CALIFORNIA COASTAL COMMISSION

REVISED CONDITIONS AND FINDINGS

Application No.: 6-10-018

Project Description: “After-the-fact” approval for the installation of an upper bluff deadman retaining system, placement of gravel on the mid and upper bluff, and construction of a seawall. New work includes placement of soil and installation of landscaping on the bluff, and aesthetic treatment of the seawall.

SUMMER HIGH SAND LEVEL SURVEY 858/860 NEPTUNE AVE.

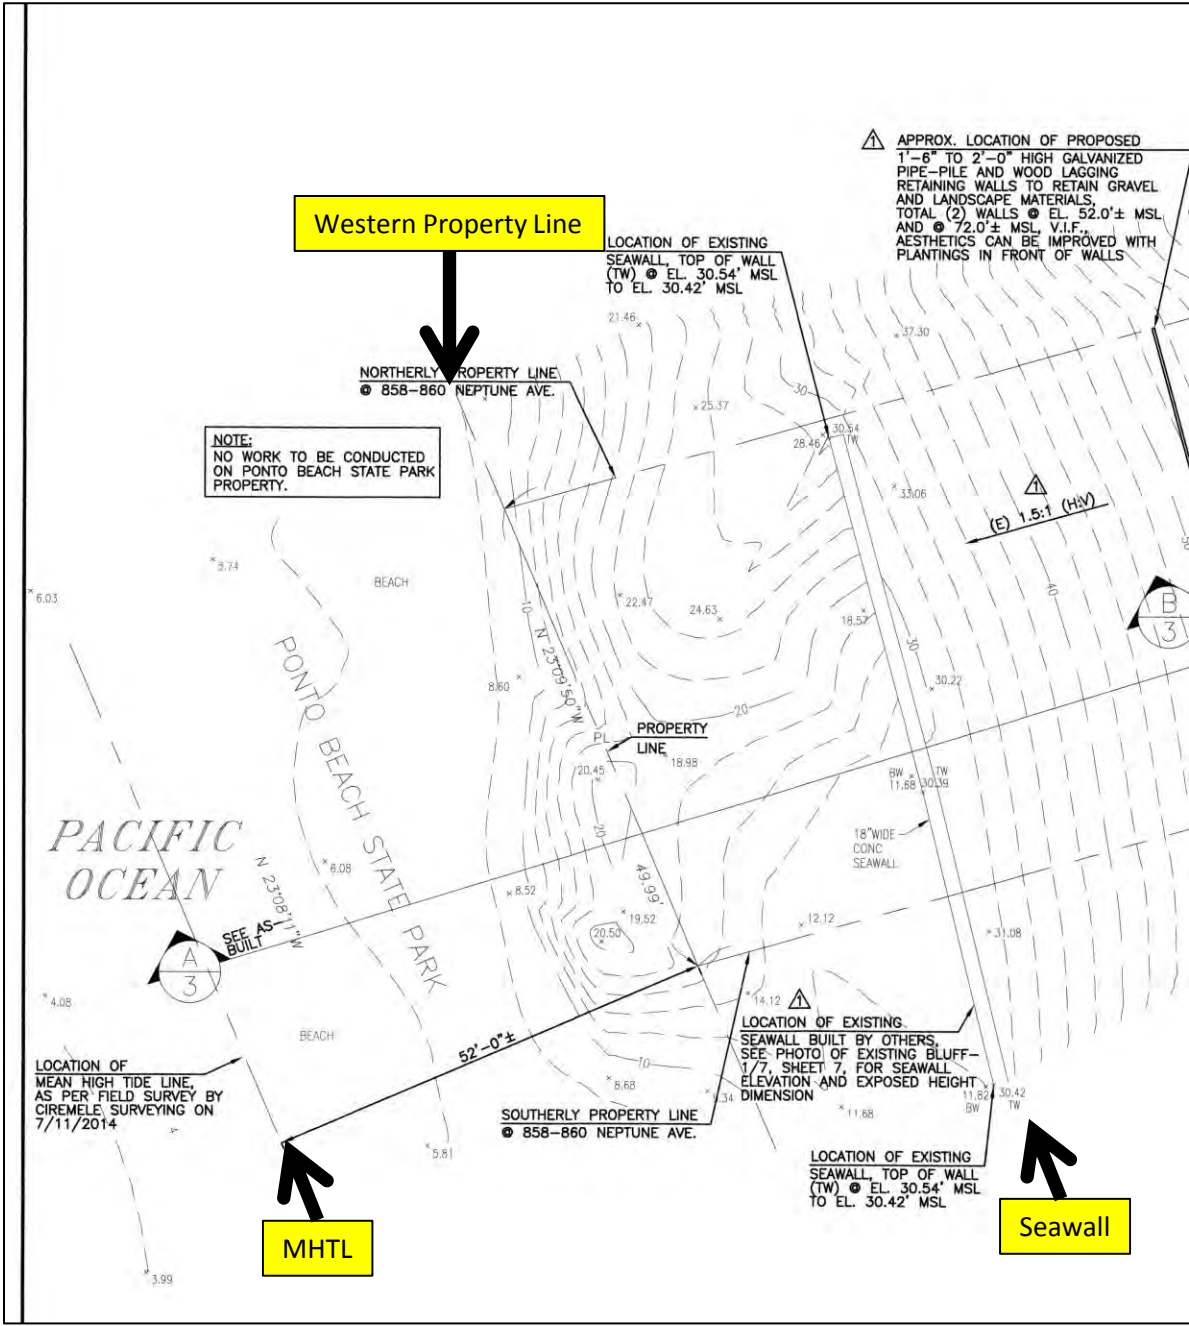
4. On page 32, it is stated, "a MHTL survey, dated July 11, 2014, for Commission review that purports to show the MHTL is located approximately 75 feet seaward of the toe of the seawall (Exhibit 7).....the California State Lands Commission(SLC) staff reviewed the MHTL survey and found thatthe seawall on the subject site **did not** intrude onto sovereign lands and that no lease, permit, or authorization was required from State Lands Commission for the portion of the seawall fronting the adjacent property (Exhibit 8)",

AS-BUILT SEAWALL PROFILE

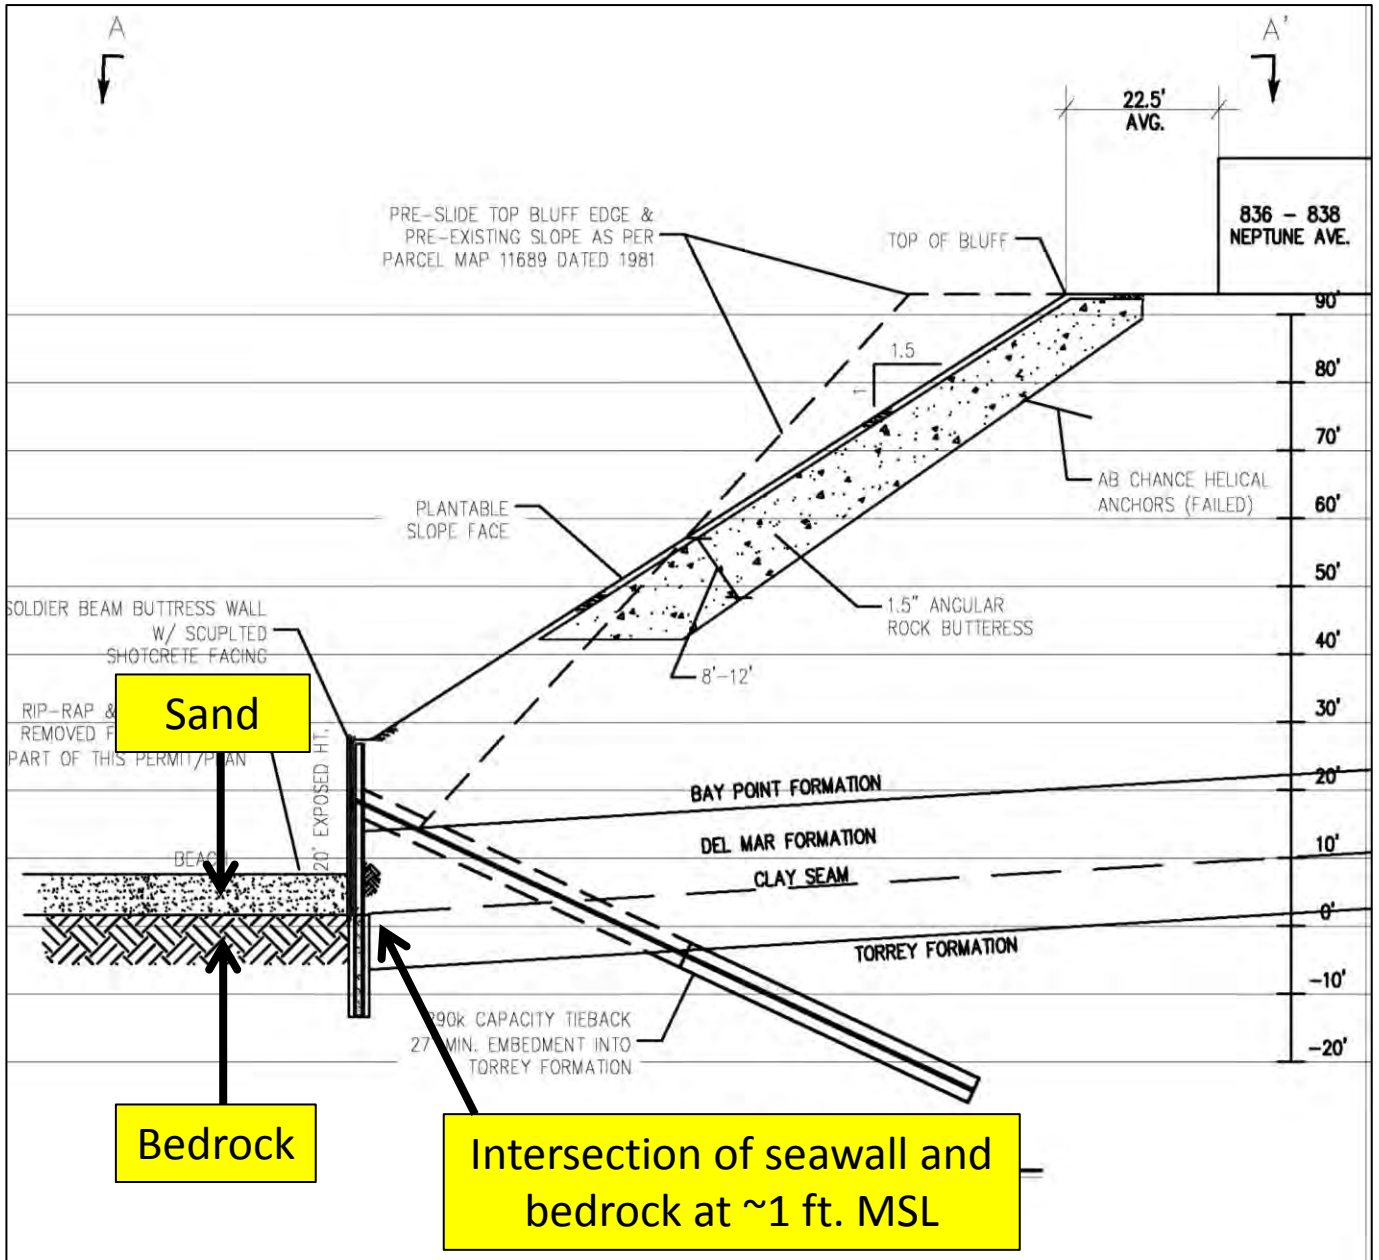
As shown on the as-built plans for the subject seawall, the intersection of the seawall and bedrock is located at approximately 1.0 ft. MSL, which is below the MHTL elevation of 1.87 ft. MSL (Exhibit 9). Had the various beach replenishment projects in the vicinity of the subject site not occurred or had the survey been conducted at the end of the winter storm season, it is likely that there would be little to no sand on this beach and the MHTL would be located at the toe of the bluff at the subject site.
